**Amendments to the Drawings** begin on page 11 of this paper and include both an attached replacement sheet of FIG. 2 and an annotated sheet of FIG. 2 showing changes.

REMARKS

*FIG. 2*

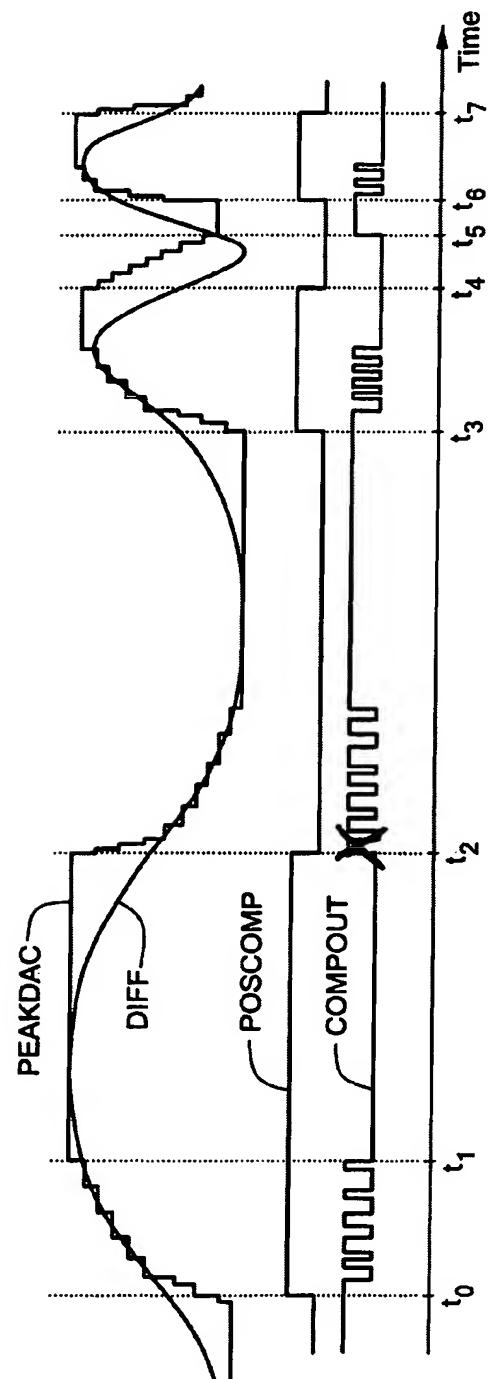
In the drawings, Applicants have amended FIG. 2 above, merely to correct a small timing error.

FIG. 2 is attached both as a Replacement Sheet and also as an Annotated Sheet Showing Changes.
